September 24, 2010

Mr. F. Thomas Lubozynski, P.E.
Waste Program Administrator
Florida Department of Environmental Protection
3319 Maguire Boulevard, Suite 232
Orlando, FL 32803-3767

**RE: RESPONSE TO FIRST REQUEST FOR ADDITIONAL INFORMATION
J.E.D. SOLID WASTE MANAGEMENT FACILITY
MODIFICATION OF GCCS SYSTEM – INTERMEDIATE MODIFICATION
ADDITION OF HORIZONTAL GAS COLLECTORS (CELL 7 THROUGH 10)
AND GCCS/LEACHATE SUMP CONNECTIONS
MODIFICATION OF PERMIT NUMBER S049-0199726-012
PERMIT APPLICATION NO. S049-199726-015**

C
32B SECTION THRU CELLS 7 AND 8

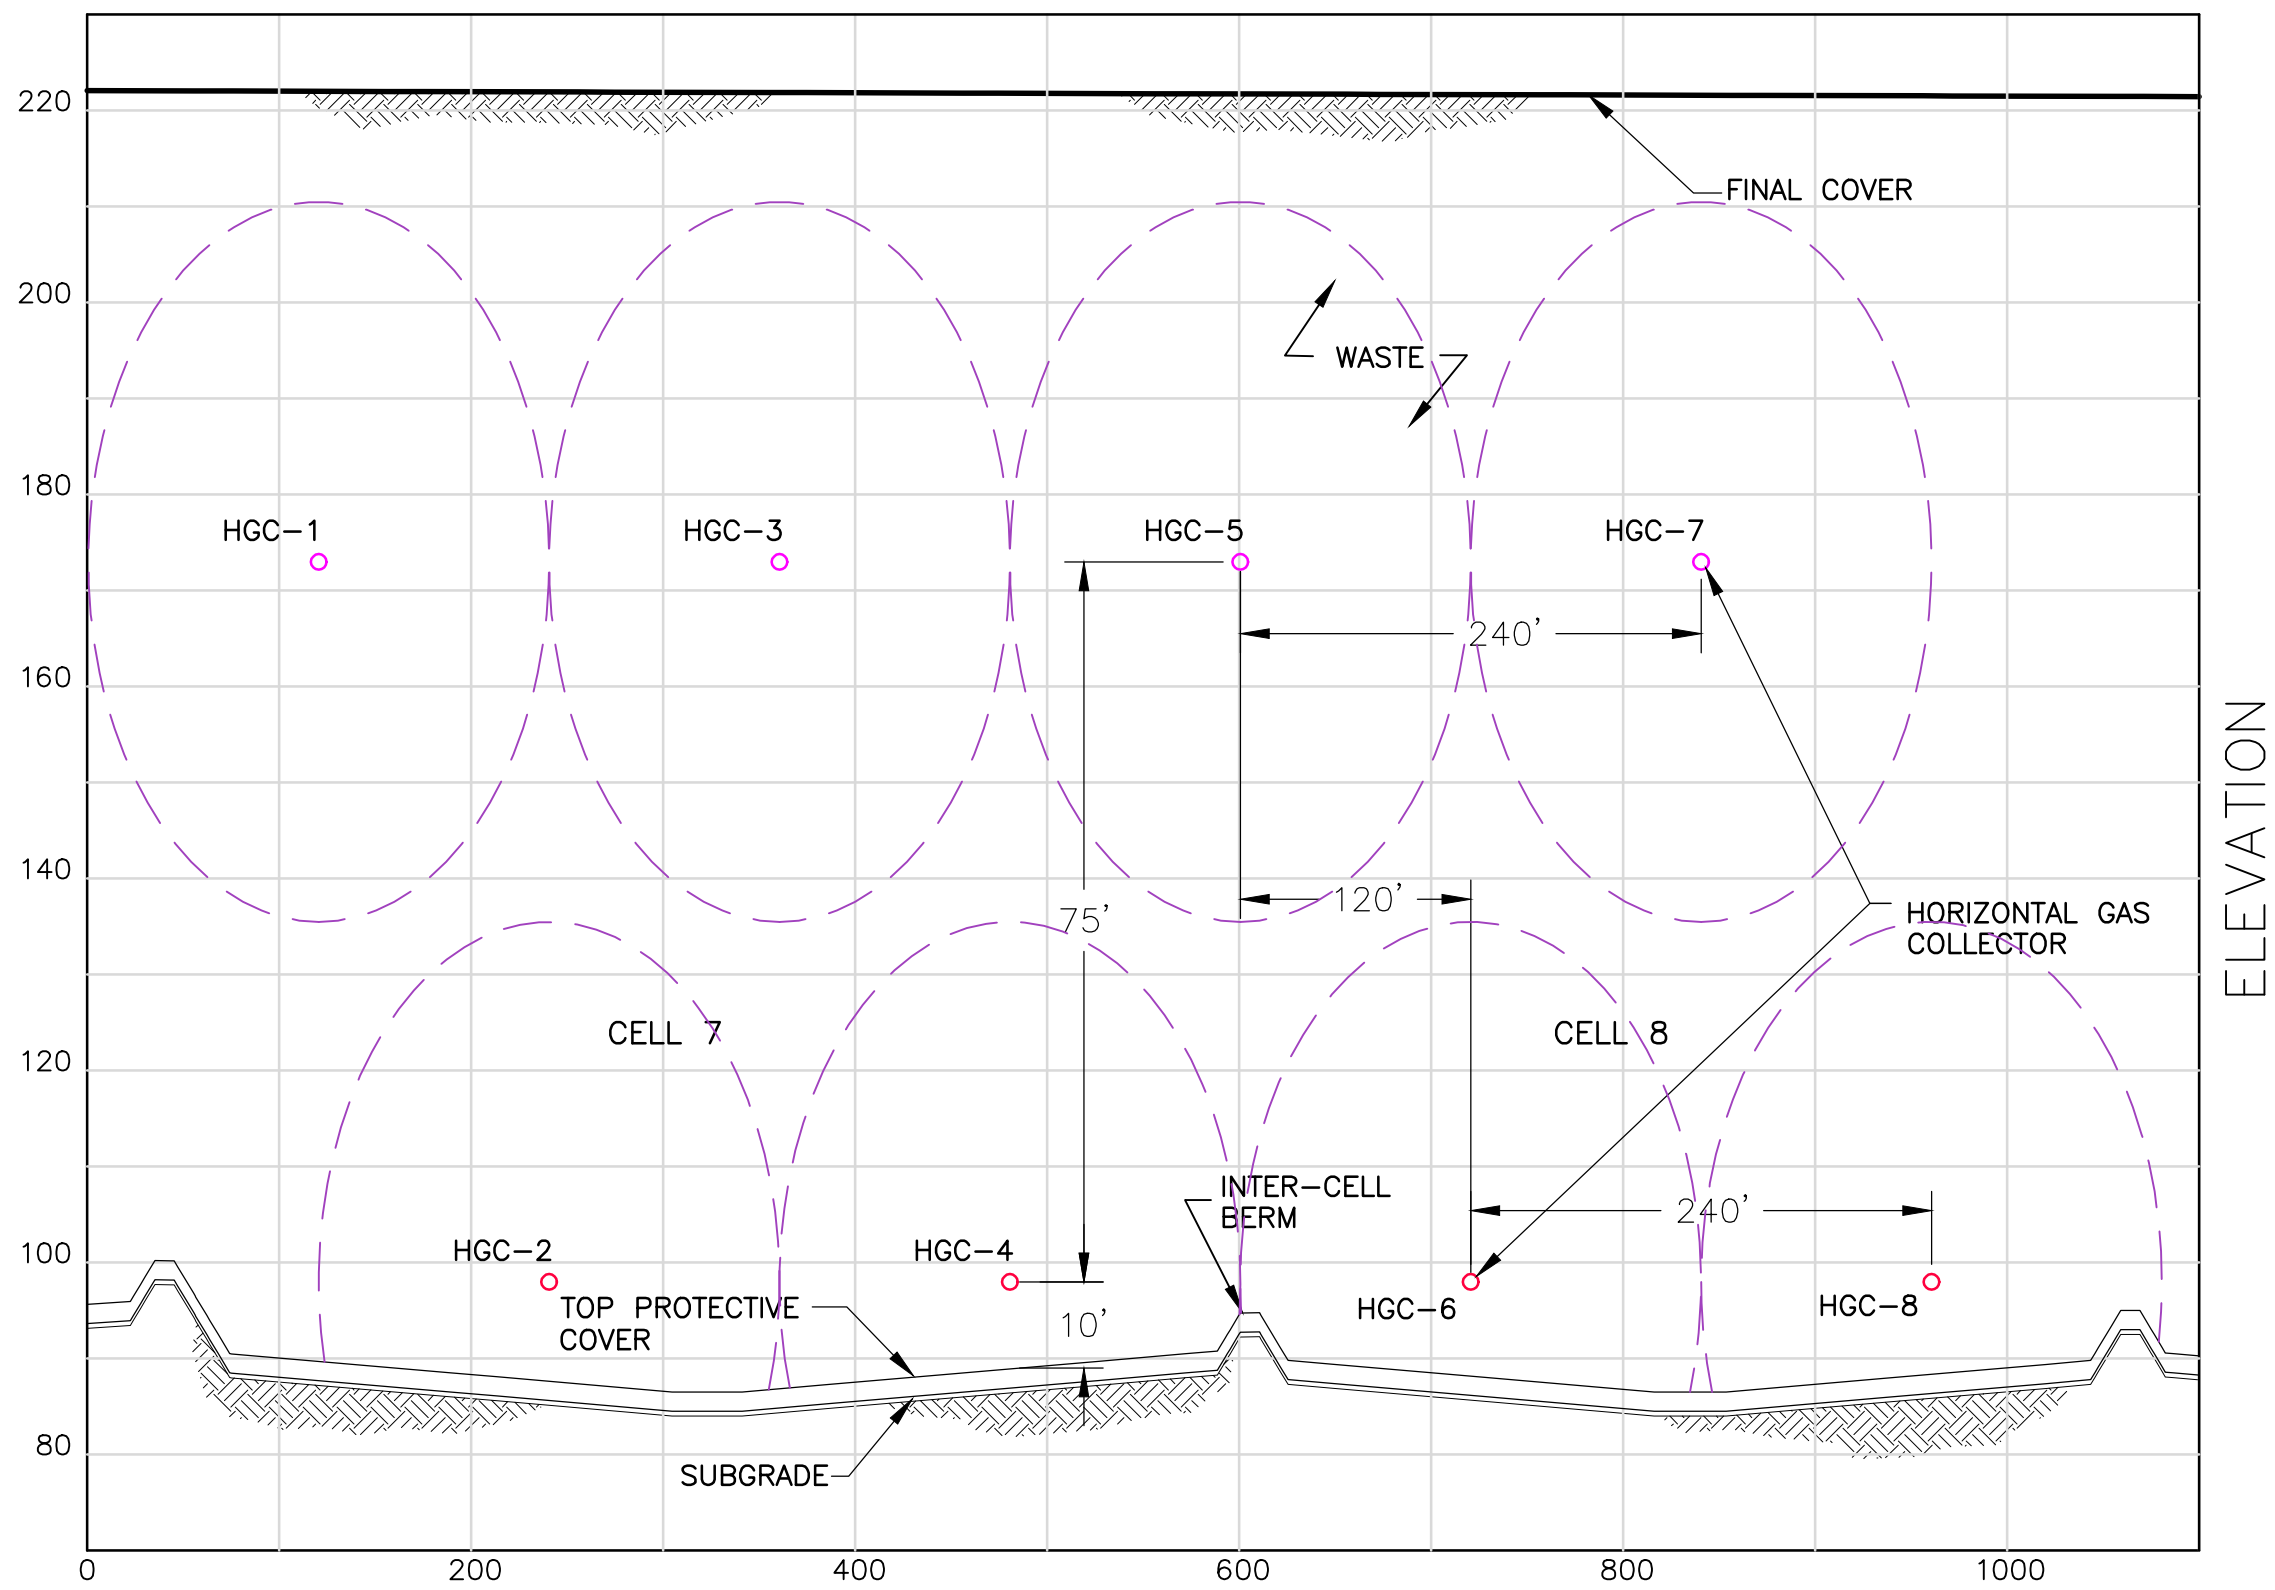
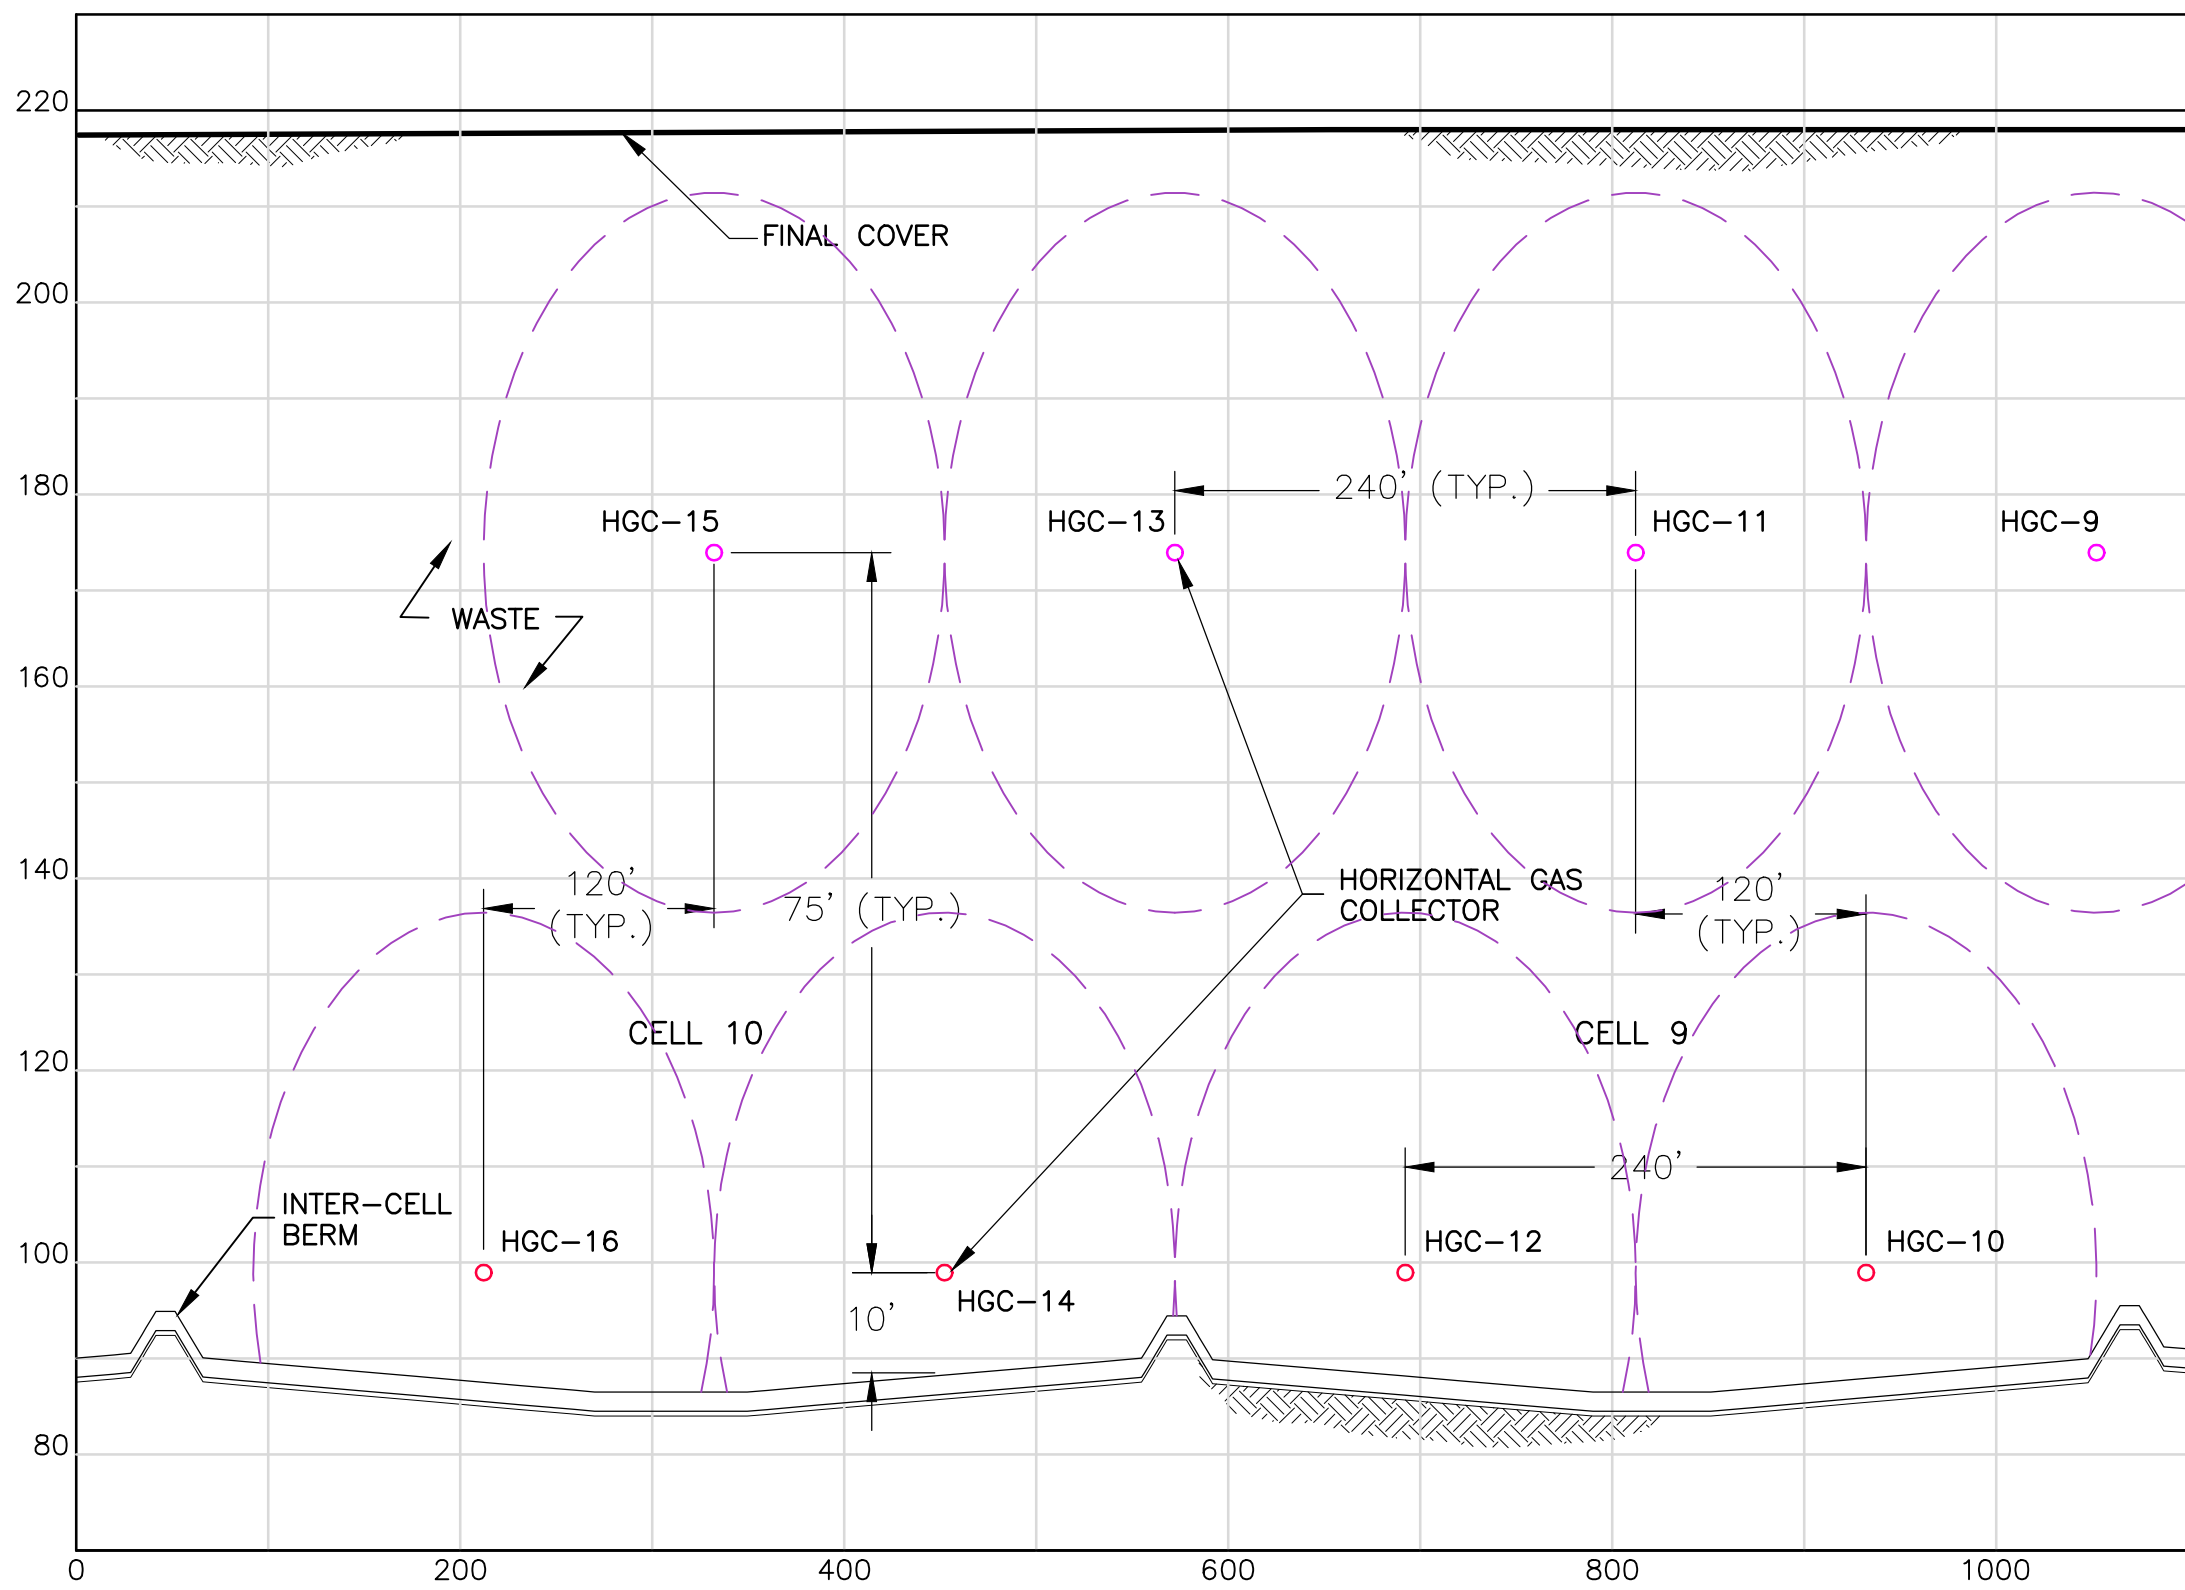
Comment 16 Exhibit 3, Drawings, Drawing No. 32B of 40: Refer to Sections C/32B and D-32B. Show the locations of the proposed vertical gas extraction wells in Cells 7 through 10. Additionally, provide a drawing that shows the radius of influence (ROI) associated with the proposed horizontal gas collectors and also the vertical gas extraction wells for cells 7 through 10. The Department recognizes that the ROI for the horizontal gas well collectors are elliptical and difficult to depict on a drawing. An approximation of these details is acceptable.

Comment 17 Exhibit 3, Drawings, Drawing No. 32B of 40: Clarify why only two rows of horizontal gas collectors are recommended as part of this permit application located at approximate elevations of 95 feet NGVD and 180 feet NGVD of waste in Cells 7 through 10. The Department Solid Waste Permit Nos SC49-0199726-006 and SO49-0199726-007 issued on April 04, 2008, in the modified Specific Condition No. A states that the final maximum top elevation for Cells 1-21 has been modified from 178 feet NGVD to 330 ft NGVD.

- a. Will there be additional horizontal gas well collectors added as more waste lifts are added beyond the 180 feet NGVD elevation?
- b. Additionally, the Sections C-32B and D-32B show final covers for Cells 7 and 8 and Cells 9 and 10 at elevations of approximately 220 feet NGVD elevations instead of 330 feet NGVD. Clarify this discrepancy and if necessary submit the revised drawing.

Response 16 Drawing No 32B has been revised to illustrate the zone of influence for the HGCs and is presented in Attachment 5. The vertical wells have not been added to this drawing as the interaction (if any) between the vertical wells and horizontal wells will not affect the performance of the GCCS. Note that the HGCs are not replacing any of the vertical wells, they are strictly being included to manage landfill gas in a more timely manner while minimizing impacts of the GCCS on operations of the facility. The vertical gas wells will still be installed as final waste grades are reached. If the HGC(s) are still operable, overlapping of the radius (zone) of influences for the HGCs and vertical wells will be managed by controlling the imposed vacuum at each respective device.

Response 17a This design calls out for only two rows of HGCs as illustrated in the application package dated July 21, 2010. Only two levels of HGCs are being proposed as they are viewed as interim gas collection devices. The installation of these two rows of HGCs will allow a more timely (likely before the mandated installation timelines for vertical well installation in the facility's Title V Permit and NSPS) as well as allow waste acceptance operations to continue unimpeded by vertical wells associated with the GCCS. Once waste operations allow the installation of the currently designed vertical gas extraction wells, the HGCs may be continue to be operated (as long as they are not watered-in and meet the operational requirements of the facility's Title V Permit and NSPS. Should the HGCs become watered-in, landfill gas will be managed with the currently design system of vertical wells.

Response 17b Sections C-32B and D-32B (as shown on Drawings Nos 29B and 32B) are cut roughly parallel to the contours of the final cover system. Omni and Golder acknowledge that the permitted final cover elevation is 330 feet NGVD, it is not at the locations shown in the application package. No revisions to the drawings were made in support of this comment.
